Subject: Watts Bar Nuclear Plant (WBN) Unit 2 – Response to Request for Additional Information (RAI) Regarding June 28, 2011 NRC Audit – Steam Line Break (SLB) and other Miscellaneous RAIs

Watts Bar Unit 2 Completion Program – Responses to Additional NRC Non-LOCA RAIs

Enclosure 3
TVA Letter Dated July 29, 2011
FSAR mark-ups for SLB transients

Figure 15.4-9 Variation of Reactivity with Power at Constant Core Average Temperature

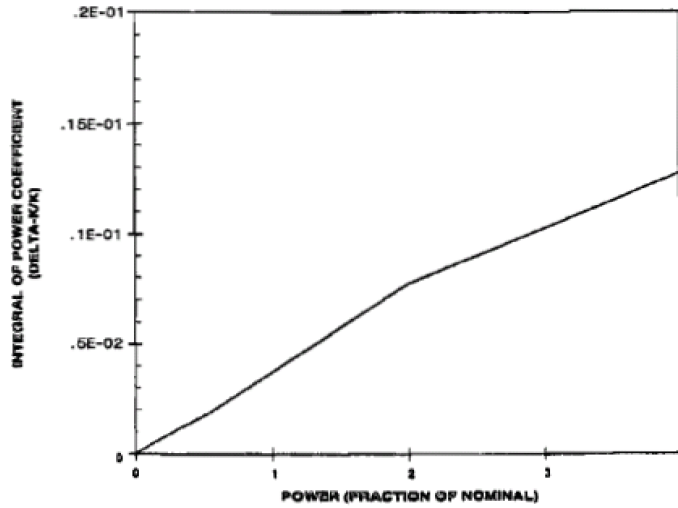
Replace with figures on next page

Figure 15.4-11a Transient Response to Steam Line Break with Safety Injection and Offsite Power (CASE A)

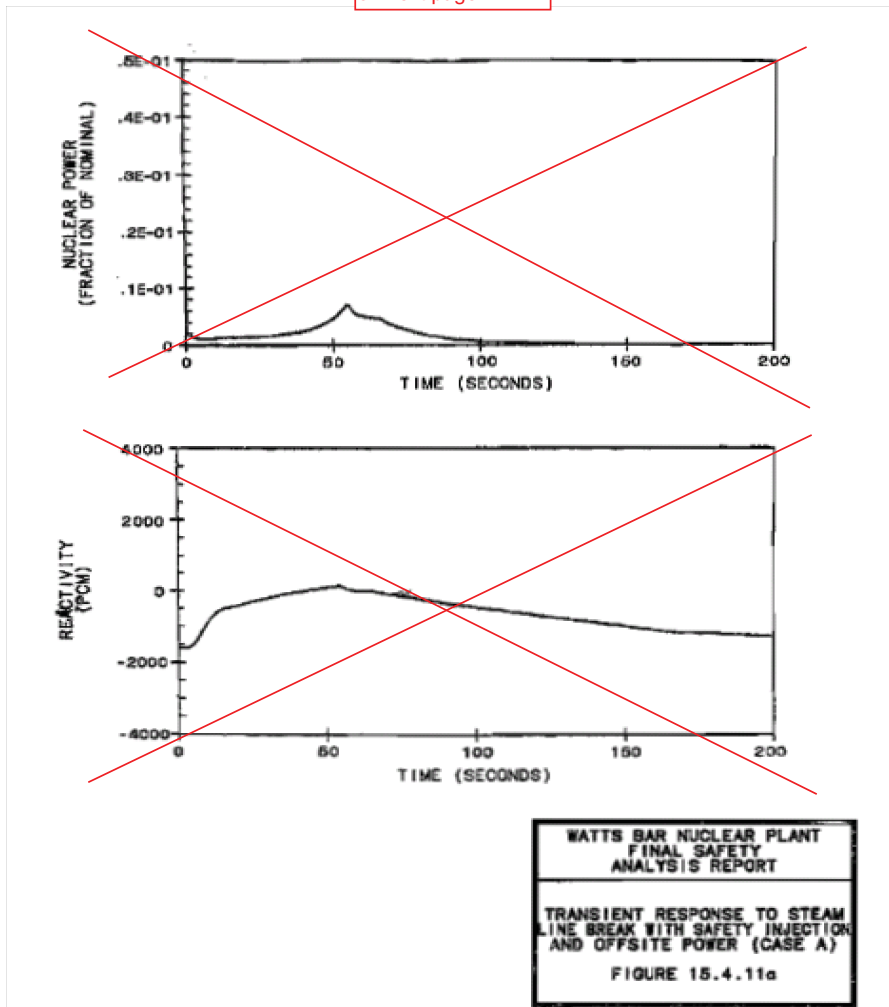
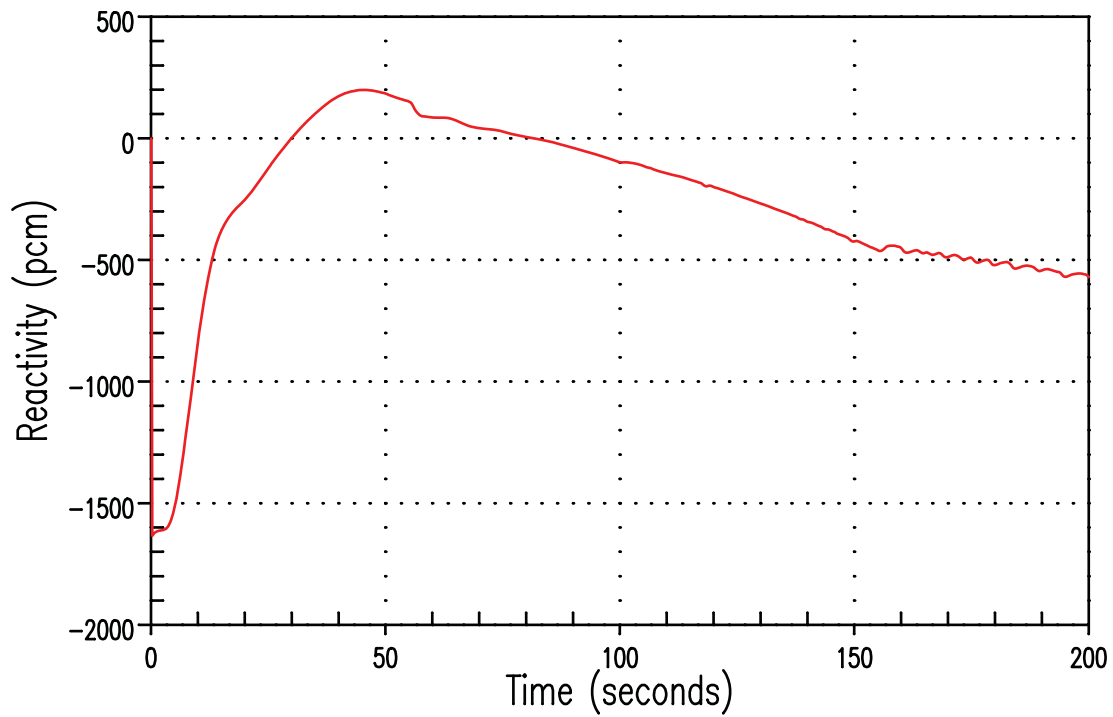
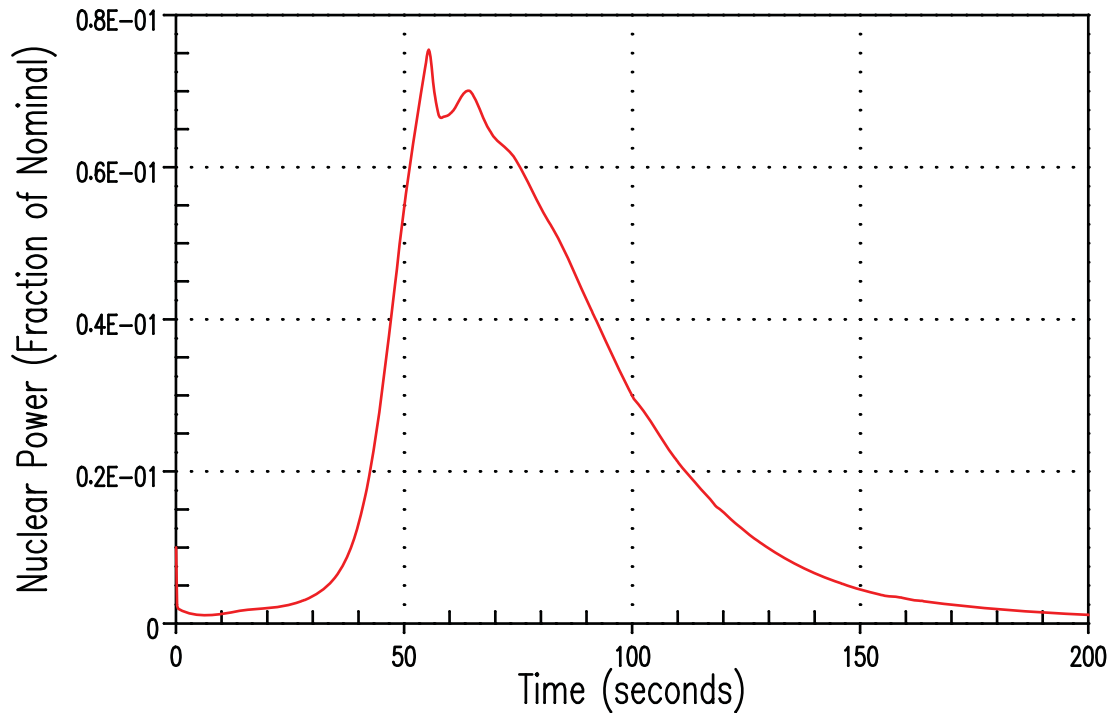
Replace with figures
on next page

Figure 15.4-11b Transient Response to Steam Line Break with Safety Injection and Offsite Power (CASE A)

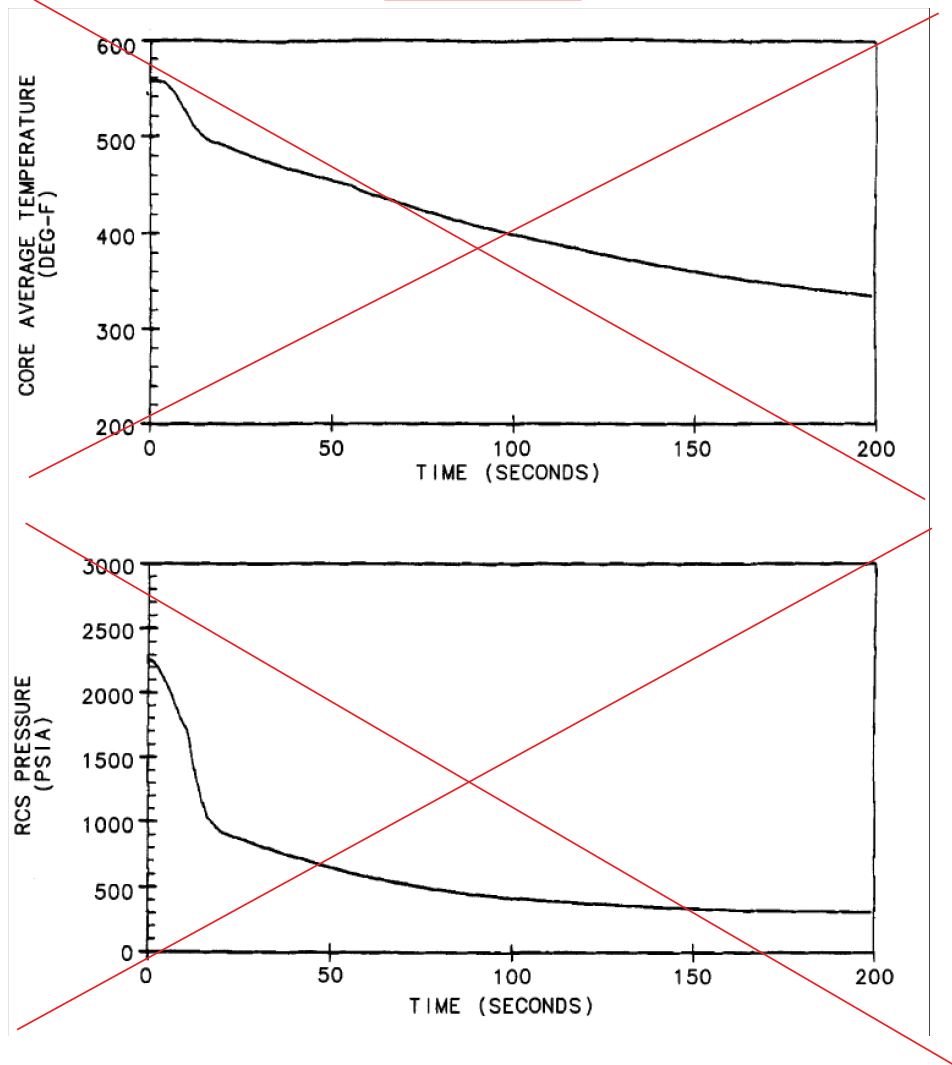
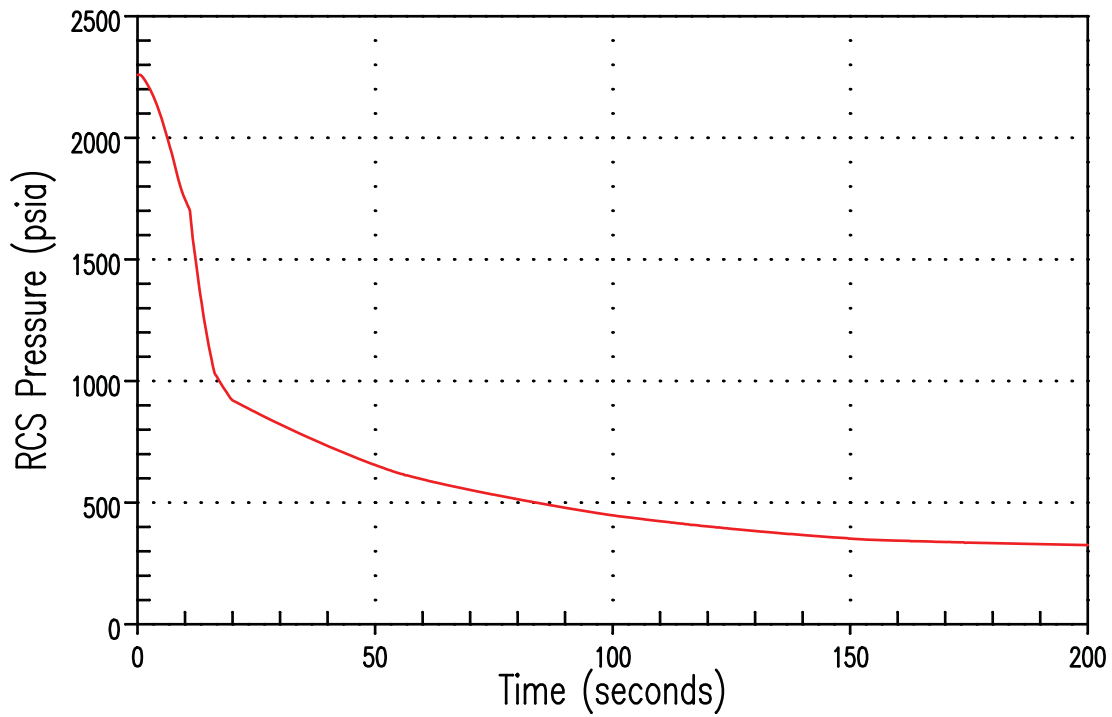
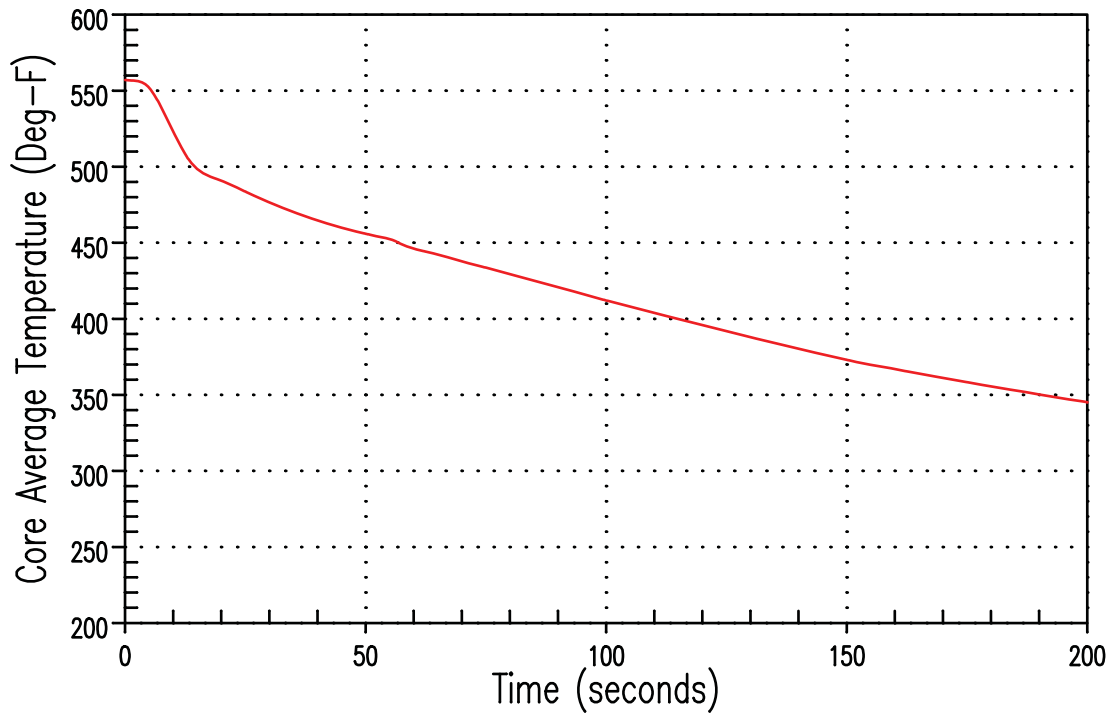
Replace with figure on next page

Figure 15.4-11c Transient Response to Steam Line Break with Safety Injection and Offsite Power (CASE A)

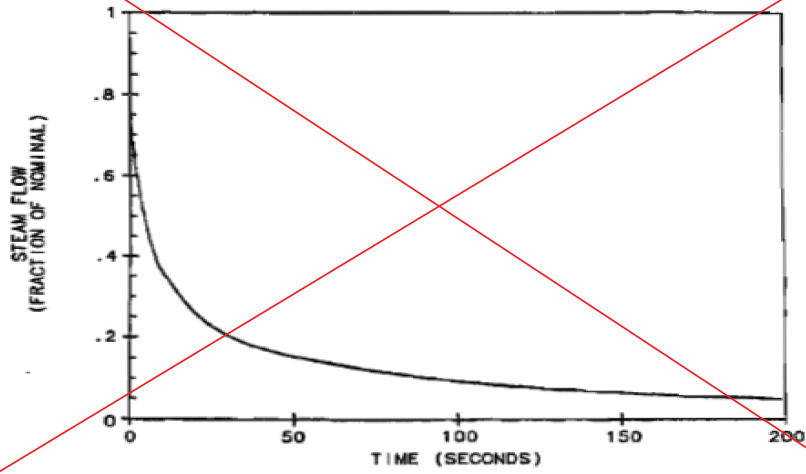
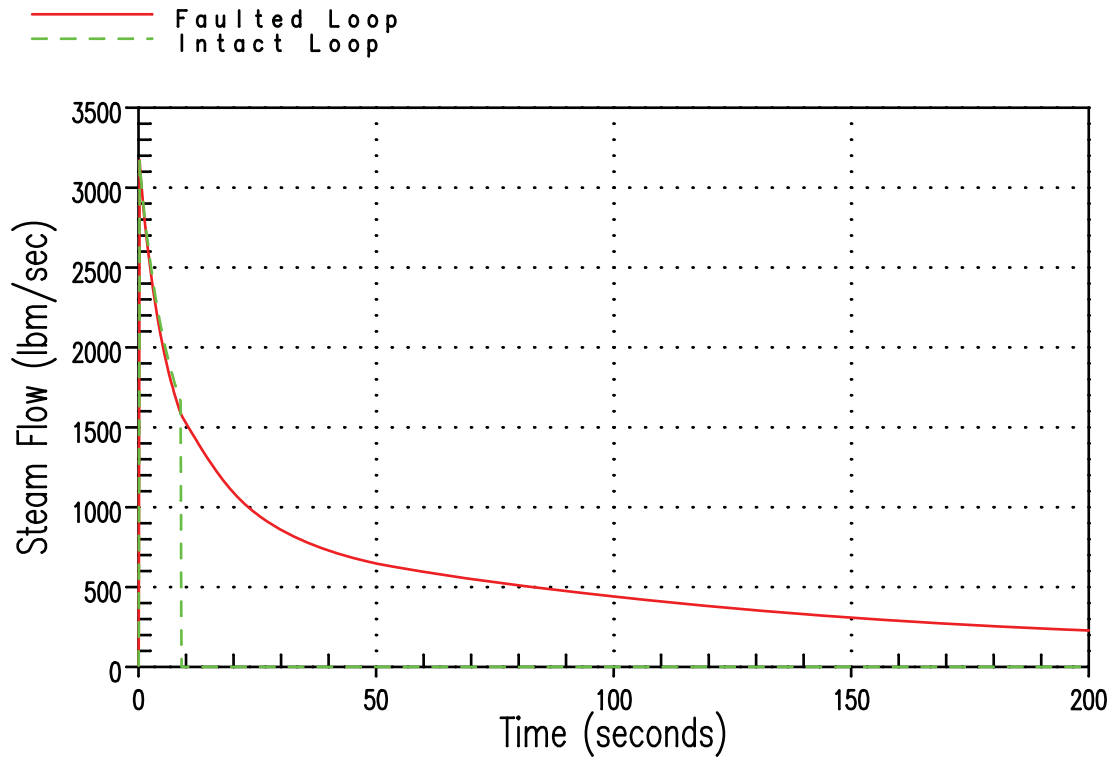
Replace with figures
on next page

Figure 15.4-12a Transient Response to Steam Line Break without Offsite Power
Nuclear Power and Reactivity Versus Time

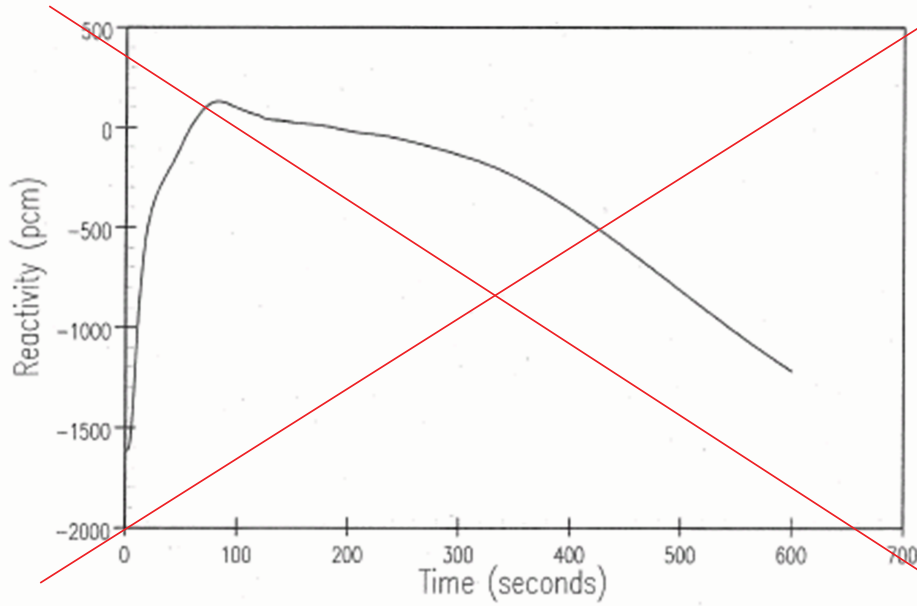
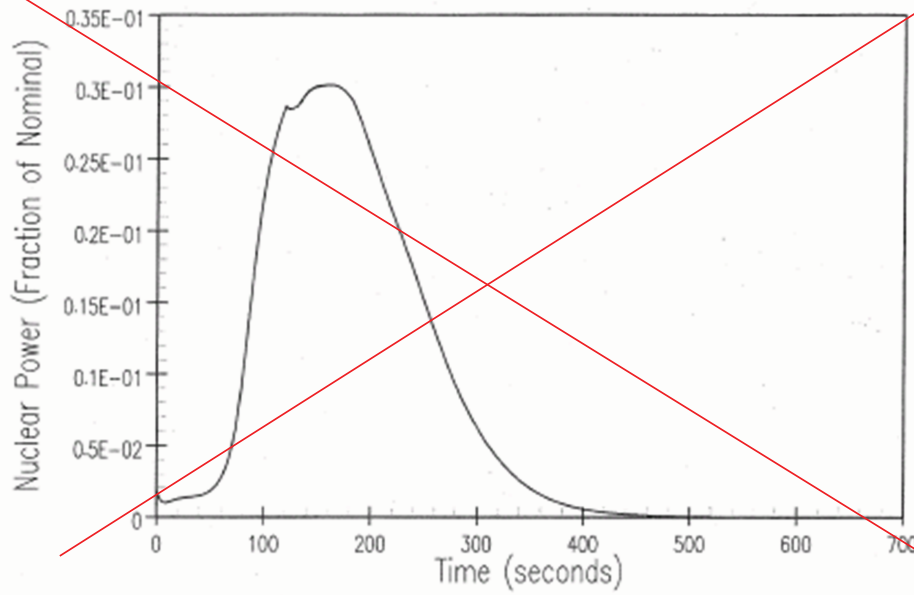
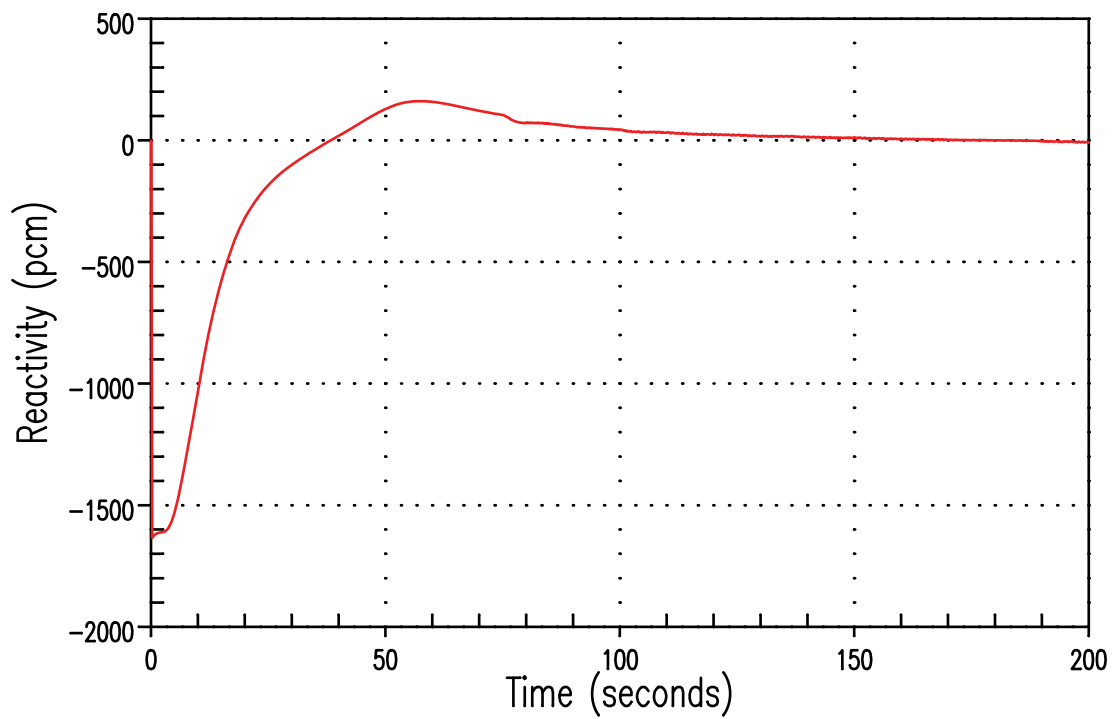
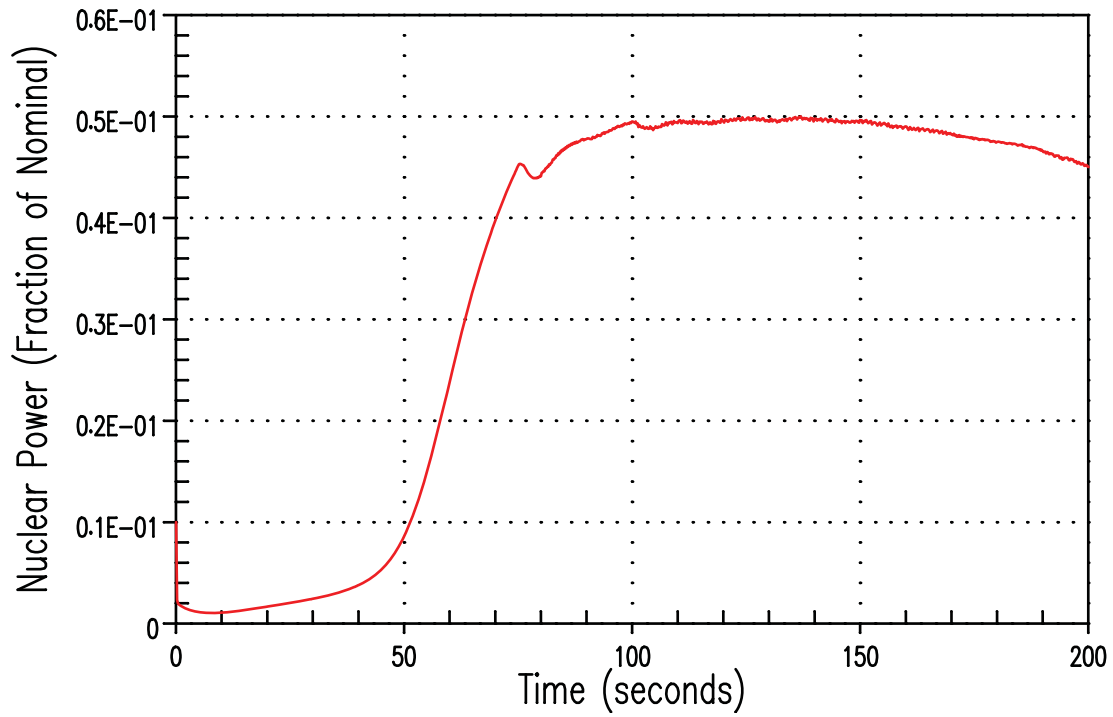
Replace with figures on next page
